**RE: Comments on Weston 7 Secondary Plan (Item 4.4)
3899, 3901 Highway 7 and 40, 60 Wings Road
City of Vaughan**

**RE: Comments on the Weston 7 Secondary Plan (First Draft)
3899, 3901 Highway 7 and 40, 60 Wings Road
City of Vaughan**

**RE: TRANSPORTATION OPINION LETTER
WESTON 7 SECONDARY PLAN & TRANSPORTATION MASTER PLAN (1ST DRAFT)
3899 & 3901 HIGHWAY 7 AND 40 & 60 WINGES ROAD, CITY OF VAUGHAN**

Figure 1: S7SP - Proposed Schedule 1, Land Use Designations

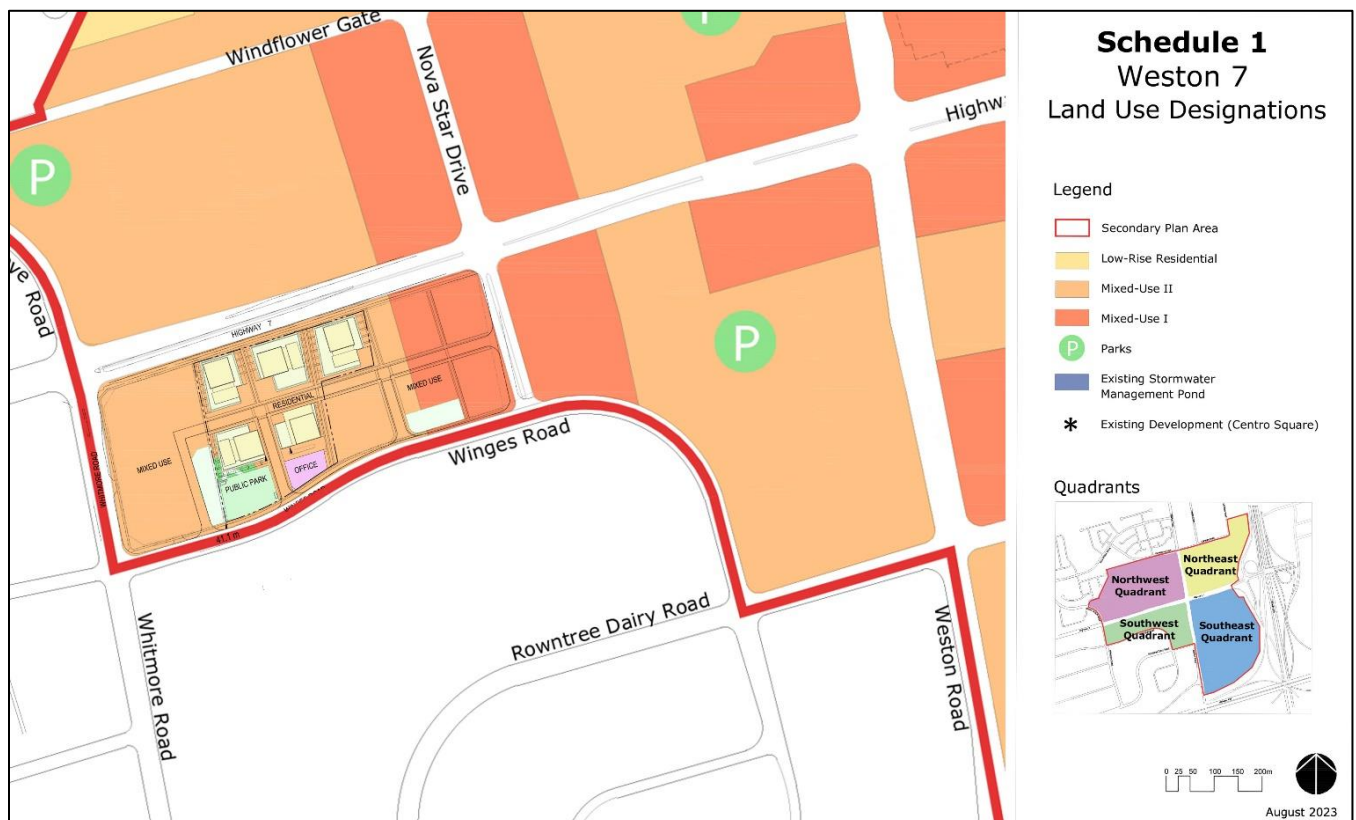
The proposed development is entirely proposed to be designated as Mixed-Use II as shown below. The following comments are provided as it relates to density and land use, as well as the policies contained in Section 5 of the W7SP.

- Policy 5.3.3 b) of the General Development Policies requires that stand-alone residential buildings are prohibitive. As noted in the development plan, the proposed development envisions (2) stand-alone residential building along with (3) mixed-use buildings and a stand-alone commercial/office building. Although we acknowledge the intent of this policy in ensuring the W7SP area develops a mixed-use/complete community, it is noted that the achievement of a mixed-use community does not require or necessitate that all buildings within the community are mixed-use. The subject property is 16,026 square metres in size and has a depth of 139 metres, fronting two public roadways, with space in between. Given the size of the subject property, it is recommended that flexibility in the application of this policy be provided so that (2) residential building in the centre of the site (with no frontage on a public roadway) be permitted to develop solely as residential buildings. This provides an opportunity for a localized residential node within the broader mixed-use community, providing optimal access to the mixed-use amenities and uses in the area.

- Policy 5.3.3. b) further requires that a minimum of 15% of a development GFA be non-residential uses. The proposed development includes 6,114 square metres of commercial/office/live-work units which provides a substantial non-residential component to the area. Although this is only 4.5%, it is recognized that the demand for office and commercial uses has been in decline and that the proposed development is not only providing ground related live-work/active uses along the Highway 7 frontage, but also 5,165 square metres of office uses in a dedicated mid-rise building to transition to the office corridor. Given the changing demands for office and commercial uses, it is recommended that staff explore a reduction in the minimum non-res component for individual sites and consider an overall target for non-residential uses within the entire W7SP area.

- Policy 5.3.3 e) within the Mixed-Use II designation, Mid-Rise Buildings should have a maximum FSI of 3.75, while High-Rise Buildings I should have a maximum FSI of 6.0, and High-Rise Building II should have a maximum FSI of 7.5. As rationalized in the following section as it relates to building height, it is our opinion that the proposed development is better identified as a High-Rise Building II site given its extensive frontage (150 m) along Highway 7, proximity to (2) MTSAs, and its frontage on multiple public roadways. Although phased, the development is being reviewed as a singular development and will be structured as such. As a combined development, the total proposed density is 8.62 FSI on a gross basis, which is only 1.12 FSI greater than the maximum permitted in the High-Rise Buildings II designation. It is our opinion that this modest increase is appropriate given other benefits the realization of this development will meet provincial mandates surrounding intensification while providing for a public park and 1,981 new residential units.

Figure 2: Schedule 2, Building Height

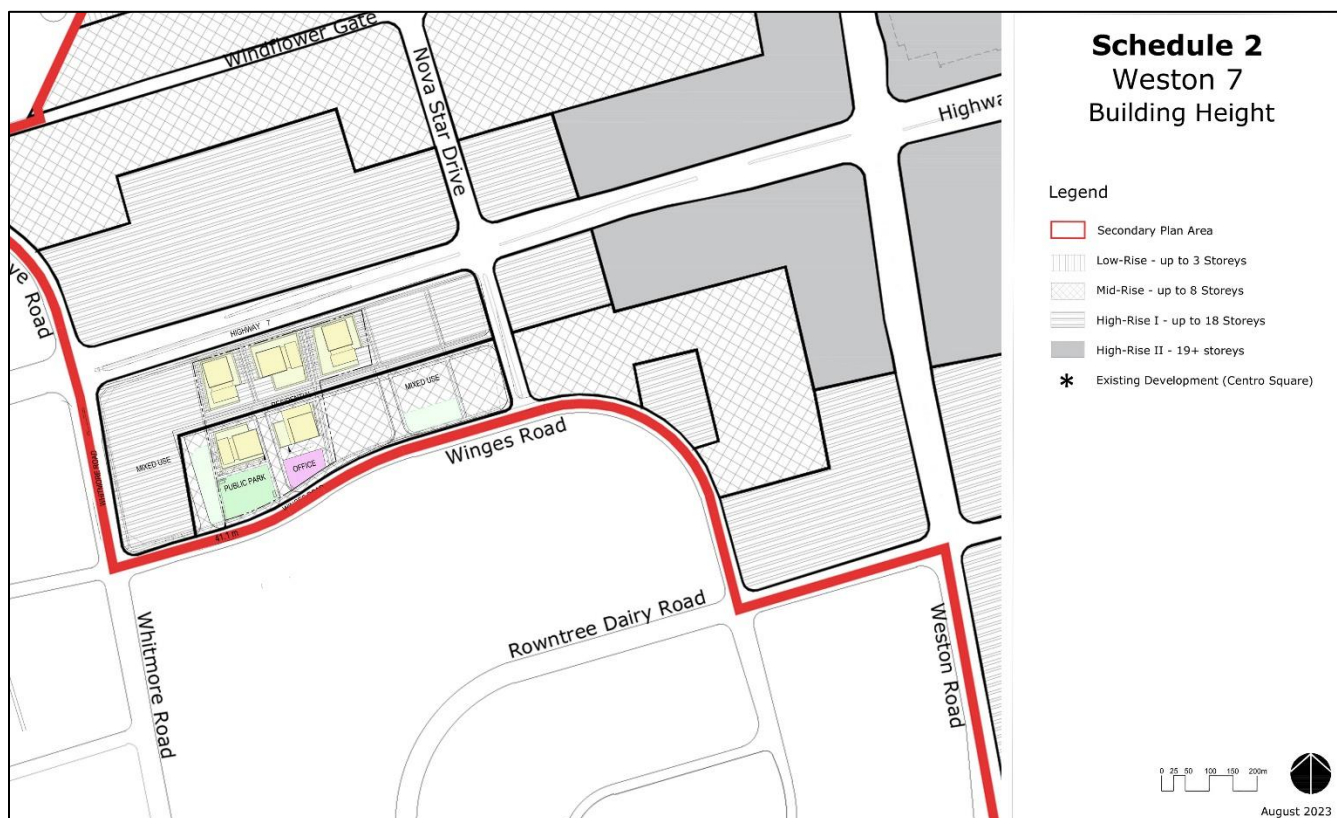
The proposed development is proposed to be have differentiated designations: *Mid-Rise, up to 8 storeys* (on the south side), and *High-Rise I up to 18 storeys* (on the north side) per Schedule 2, Building Heights, illustrated on Figure 2. As such, the (3) buildings along Highway 7 are proposed to be *High-Rise I*, while the (3) buildings to the rear are proposed to be *Mid-Rise*. The following comments are provided as it relates to building heights, as well as the policies contained in Section 4.2 of the W7SP.

- 4.2.4 a) has a discrepancy in the maximum height permissions from the policy text vs. the proposed schedules. In the policy, the maximum height permissible for the High-Rise I designation is 20 storeys (vs. 18 storeys on Schedule 2) and for the High-Rise II designation is 32 storeys (vs. 19+ on Schedule 2). It is advisable that this be clarified and corrected.

- 4.2.3 a) provides for a maximum Mid-Rise Building height of 8 storeys or 27 metres. It is noted that Section 9.2.3.5 of the Vaughan Official Plan, and the generally accepted urban design principle is that a mid-rise building is defined as building over 5-storeys and up to 12-storeys. We question why the W7SP proposes to seek a lower maximum height permission for mid-rise buildings given the need for more housing and development potential for the area. Despite this, the proposed 8-storey office building at the rear of the development conforms to the permissible height regime.

- Schedule 2 focuses the High-Rise II designation towards the Highway 7 and Weston Road intersection only; however, the W7SP encompasses a broader development area and subject lands is serviced by two separate MTSAs. As such, it is our opinion that from a city building perspective, the High-Rise II designation should be spread along the Highway 7 corridor more broadly than presently proposed, allowing for lower building heights on areas that do not have frontage along Highway 7. Highway 7 is a Regional Intensification Corridor and a “*major focus for intensification on the lands adjacent to major transit routes, at densities and in a form supportive of the adjacent higher-order transit*”. Further, this portion of Highway 7 includes a BRT service with access to two stations and the widest right-of-way in the Region. Given the size of the roadway and extensive public realm and boulevard treatments, taller heights along the full extent of Highway 7 should be permitted.

Figure 3: Schedule 3, Pedestrian Realm Network

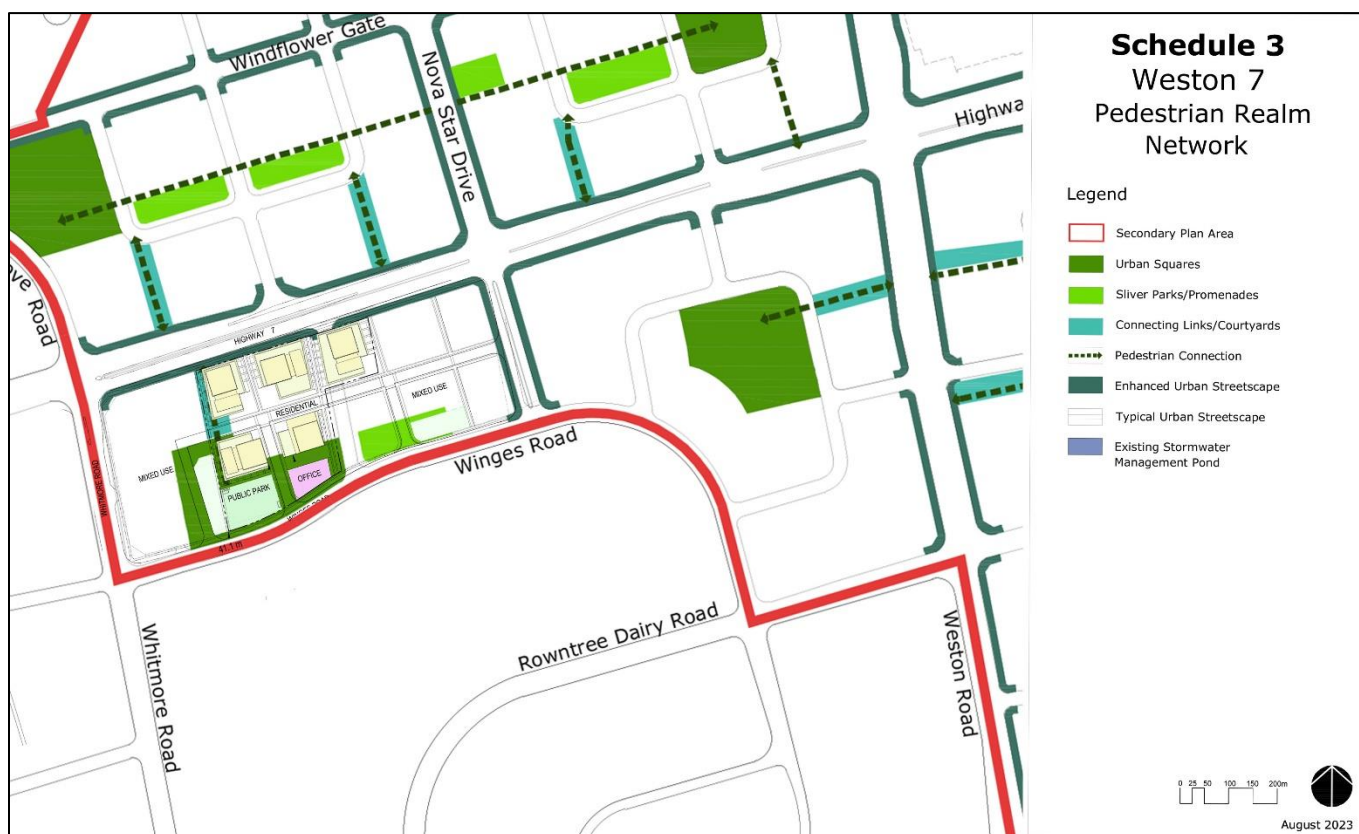
Schedule 3, Pedestrian Realm Network includes a number of proposed public parks, opens spaces and linkages to be coordinated throughout the W7SP area. In particular it proposes an *Urban Square* along the southern portion of the subject property, as well a *Pedestrian Connection and Connecting Links/Courtyard* along the western property boundary linking the proposed public park to Highway 7. Also envisioned is an *Enhanced Urban Streetscape* along Highway 7.

- While it is recognized that the W7SP has accounted for the proposed development and has generally proposed the public park and linkages in coordination with the submitted proposal, we note that some discrepancies still exist between Schedule 3 and the submitted plans. It is recognized that the W7SP has also considered the neighbouring development application to the west; however, it is noted that the proposed public parkland required for the quadrant has disproportionately been applied to the subject lands, while other lands within the block are not providing an equitable amount of potential park lands. The portion of the proposed Urban Squares presently located where the 8-storey office building is proposed should be shifted to the abutting parcels to the east for a more equitable distribution of parkland, providing more convenient access to public park space to all future residents within the block.

The proposed development is currently proposing to convey 1,603 square metres of public parkland, representing 10% of the development site, which is consistent with Policy 8.1.10 g). This park has been strategically positioned to seamlessly connect with the proposed public park of the adjacent western development, resulting in a larger community park covering approximately 3,093m² once fully realized. This integration delivers a substantial community benefit and significant overall parkland contribution to the southwest quadrant to serve the neighbouring developments. As such, an enlarged park beyond what is currently proposed is not required to service the immediate vicinity of the parks space. If the city is intent of exploring additional park lands, it would be more equitable and appropriate for the additional park lands being proposed in the W7SP to be shifted to the east, allowing for more convenient access to parks space within all

Figure 4: Schedule 4, Transportation System

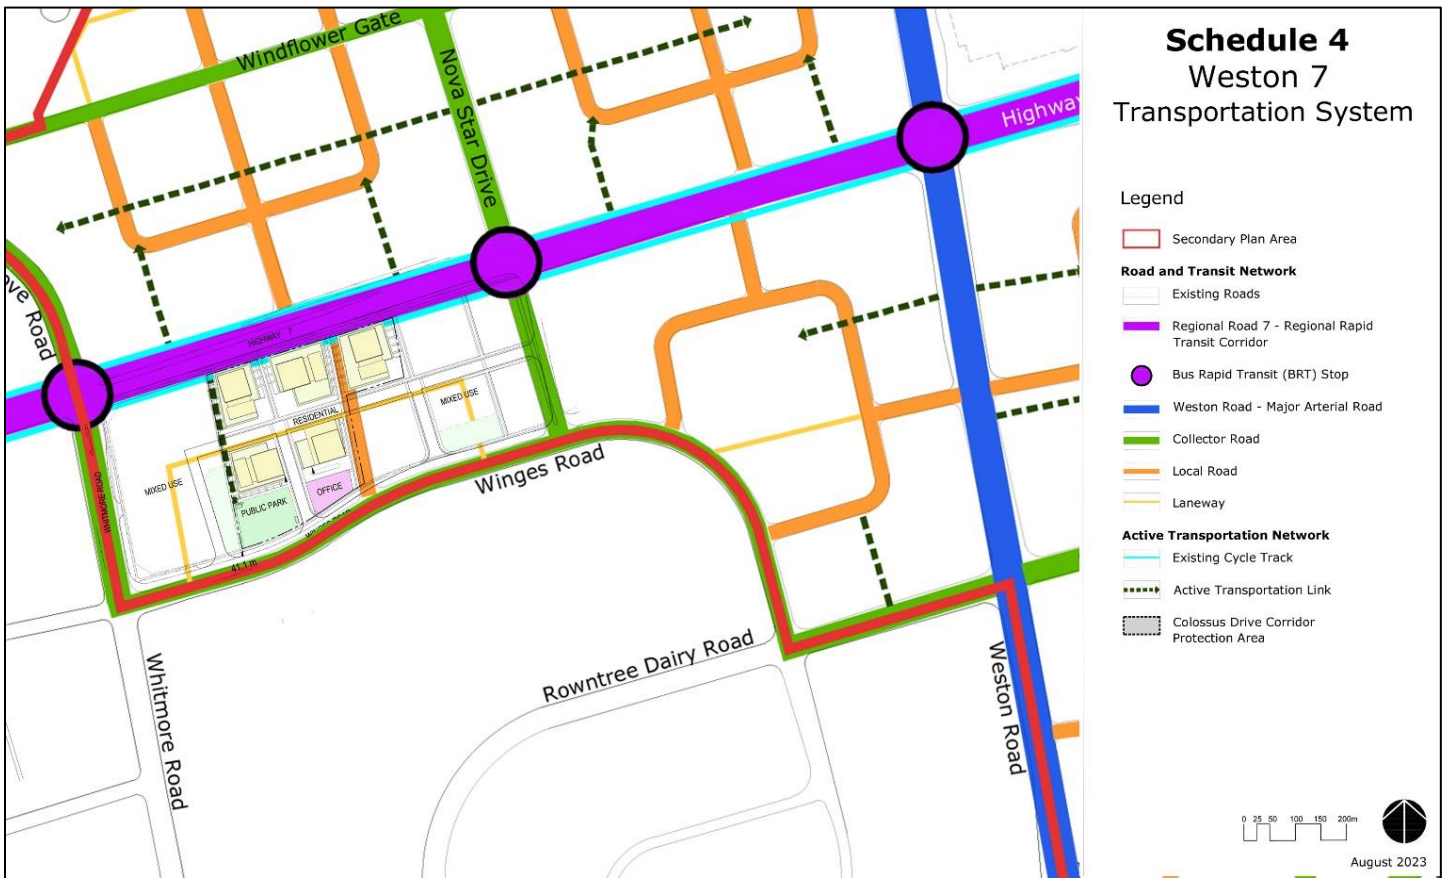
The proposed development prioritizes pedestrian connectivity and active transportation over vehicle usage given the site’s location between (2) VIVA Stations and within a delineated MTSA. Schedule 4, Transportation System proposes an east-west *Laneway* that bisects the property, which is in line with the current development proposal, while also generally aligning with the intended road pattern subject to minor deviations in alignment. Also proposed is a *Local Road* for the eastern perimeter of the subject property, creating a link between Wings Road and Highway 7. The proposed development includes (4) direct pedestrian linkages and or mews’ to Highway 7 from the internal areas of the site in order to promote active transportation and the prioritization of pedestrian movement.

Crozier and Associates submits the attached Transportation Opinion Letter which concludes that although they are generally in support of the of the larger area-wide recommended transportation improvements, the new proposed north-south public road connection between the Nova Star Drive extension and Whitmore Road which bisects the Subject Property is not necessary from a traffic capacity perspective and would not be preferable from a safety perspective. The proposed new road will introduce additional conflict points between vehicles and non-auto transportation users and likely introduce significant cut-through traffic to the quadrant in an attempt for automobile traffic avoid delays and congestion issues at the critical Weston Road and Highway 7 intersection. Please refer to the attached Transportation Opinion Letter for additional discussion.
